# INSTRUCTION TO SERVICE

ITS61661		April 10, 2026
<b>SECTION:</b>	260 – Battery System	
<b>SUBJECT:</b>	Replace XALT ESS batteries with ABS ESS batteries on XE40 6 to 5 str	
<b>ISSUE:</b>	Freudenberg Gen 3 batteries (XMOD125E, XMOD123E, XMP123E) recall.	
<b>SUMMARY:</b>	Replace XALT ESS batteries with ABS ESS batteries, change coolant and rework existing harness.

Ref. NHTSA Recall No.	Ref. Transport Canada Recall No.
25V631	2025-495

**Figure 37: Coolant Hoses Replacement of Removed ESS Pack**

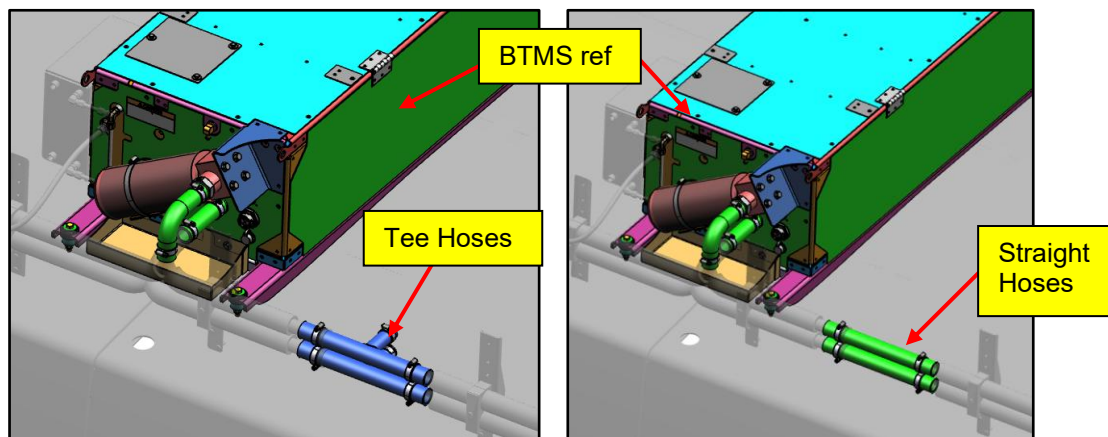
76. Replace the two coolant tee hoses of the removed ESS pack with straight hoses (NF PN: 1166123).

- If bus is equipped with waveseal clamps, torque to 80 in-lbs. Reapply torque marks.
- If bus is equipped with breeze clamps, torque to 40-45 in-lbs. Reapply torque marks.

**Figure 45: Sight Glass Relocation and Plumbing of BTMS Rework Reference**

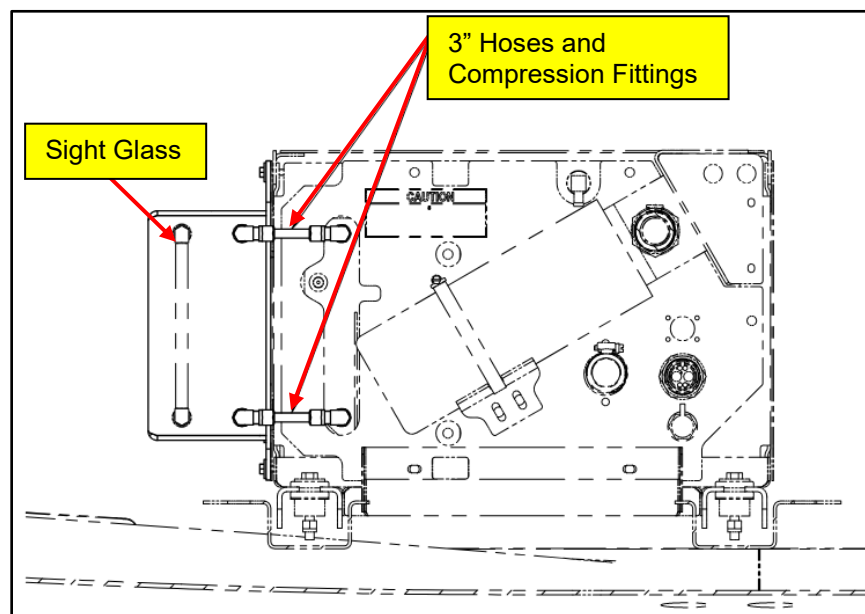
93. Remove BTMS sight glass tube and reinstall into ports on surge tank. Trim hose supplied in kit into two 3” sections and install hose sections and compression fittings in kit to join surge tank plumbing to BTMS. Torque all compression fittings to 18 Nm.

**Figure 47: Pothead Interior Side**

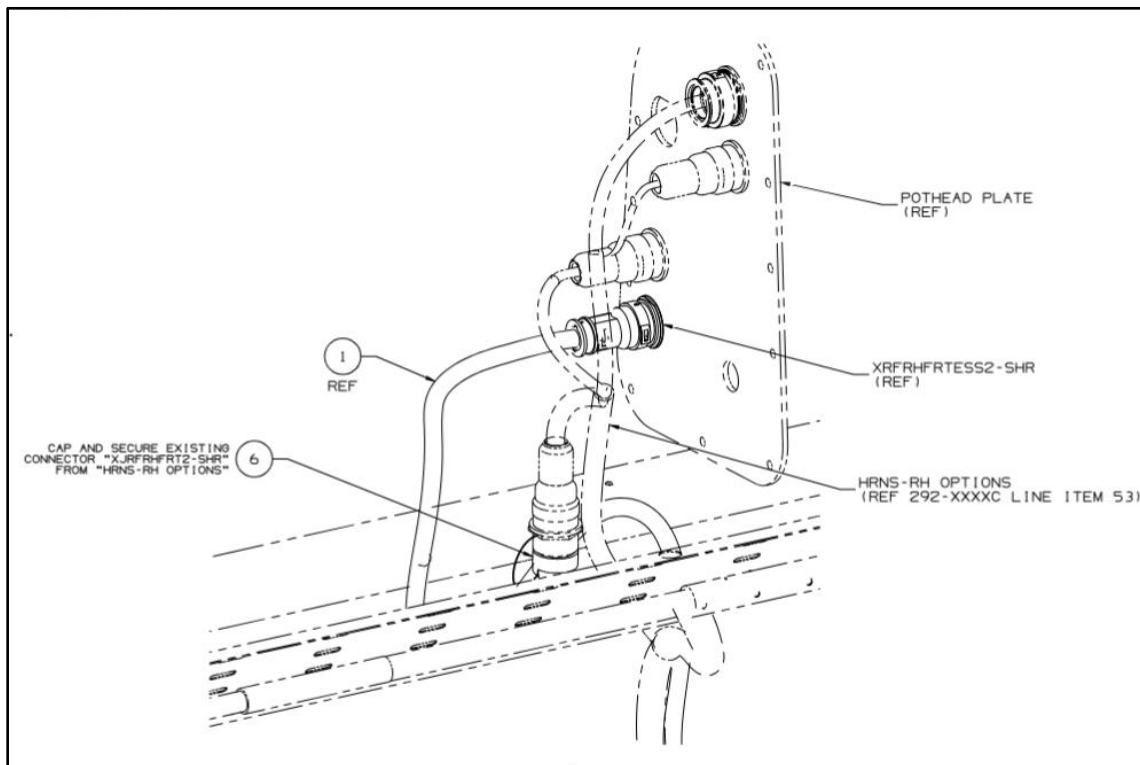
96. Disconnect existing connector XJFRHFRT2-SHR. Secure and cap using (NF PN: 182470).

**Figure 55: MCU TCU Harness Rework**

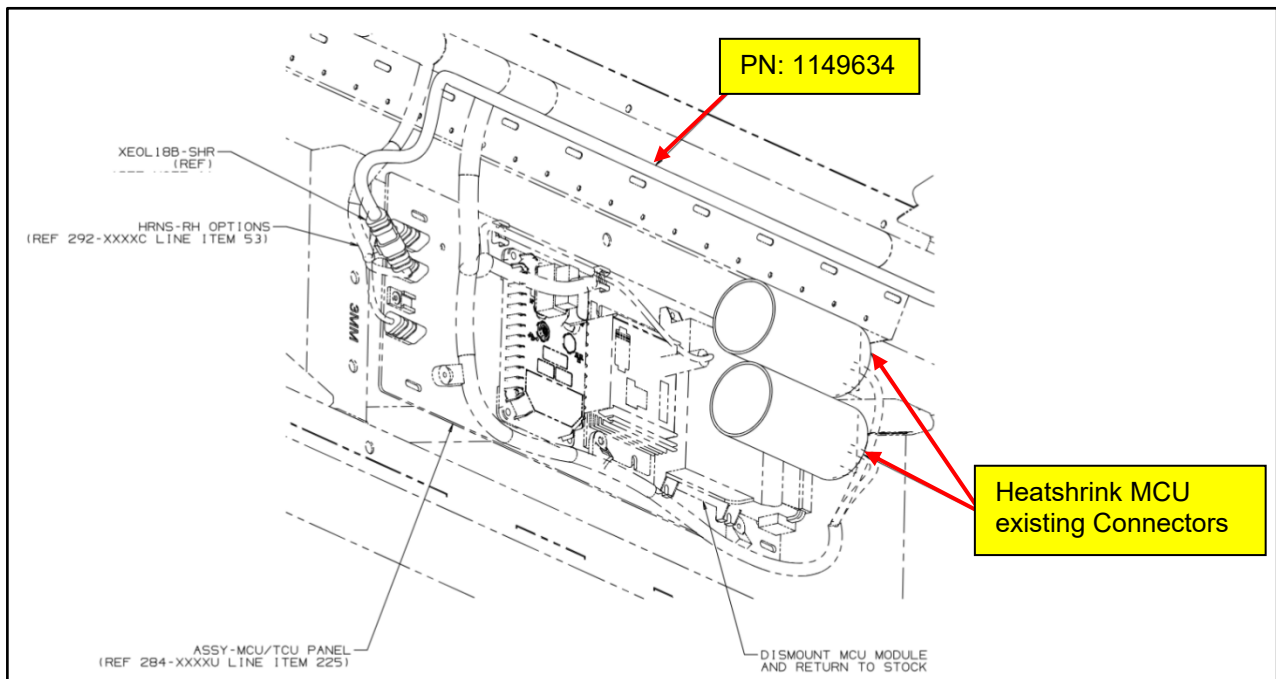
109. Ensure "XEOL18B-SHR" from jumper harness (NF PN: 1149634) mates with "EOL18B RES-TWR" from HRNS-RH options ref 292-053C. Discard existing resistor cap from "EOL18B RES-TWR", then relabel connector as "XEOL18B-TWR".

110. Cap and secure existing connectors "MCU-285" & "MCU-295" from "HRNS-RH OPTIONS". Apply shrink tubing (NF PN: 053084) over front of connector, shrink, then fold and secure using cable ties.

111. Dismount MCU module and return to stock.

**Figure 70: Orifice on ESS String # Reference**

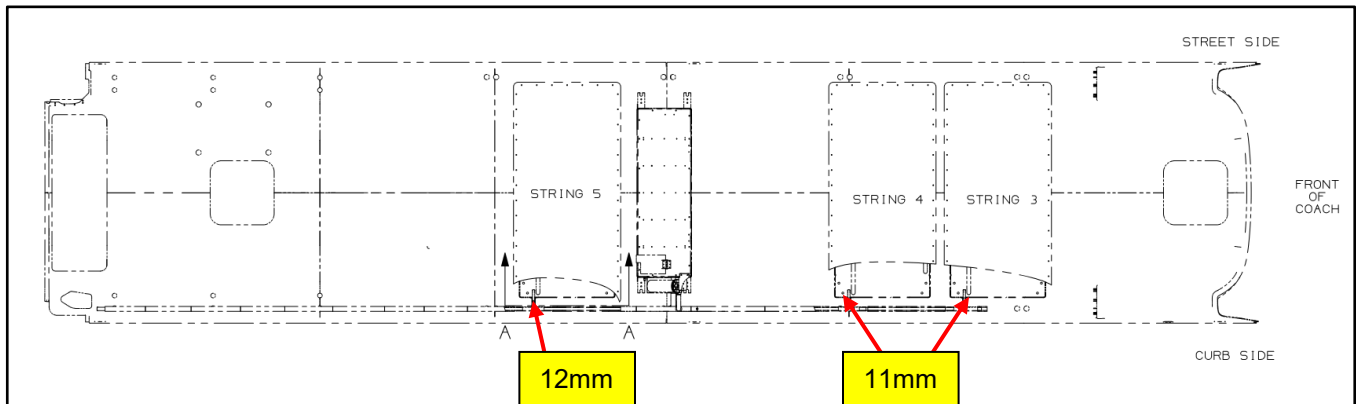
145. Prior to installing the coolant hoses, inspect the supply (lower) tube to ensure the new correct size orifices are installed.
  - 11mm Orifice (NF PN: 1084632) is used on string 3 and 4.
  - 12mm Orifice (NF PN: 1084631) is used on string 5.

**Figure 78: Reinforcement Brackets Added on Existing Rear Rack**

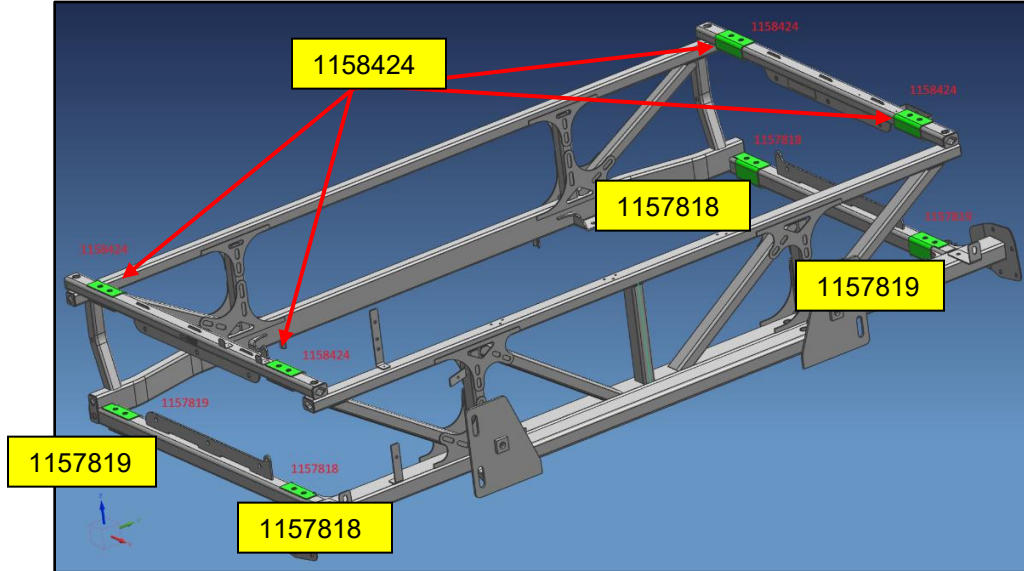
**Note: Clean/Grind out surface of tubes where these brackets go as required.**

**Figure 86: Replace Coolant Plates**

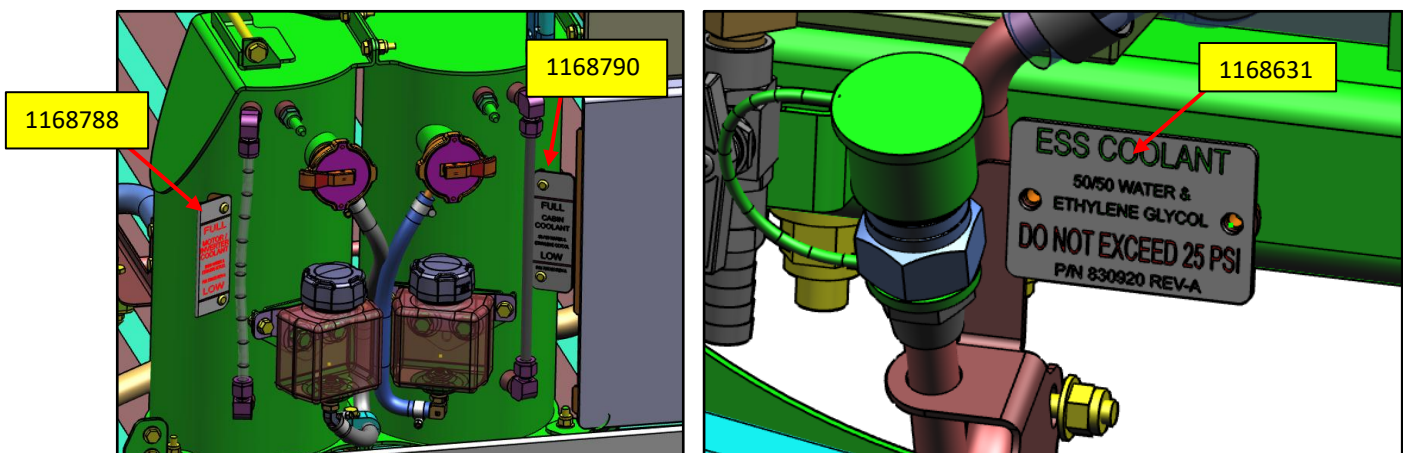
183. Replace all existing coolant plates i.e. motor/inv, cabin and ESS with new coolant plates. (NF PN: 1168788, 1168790 & 1168631). Reuse hardware.
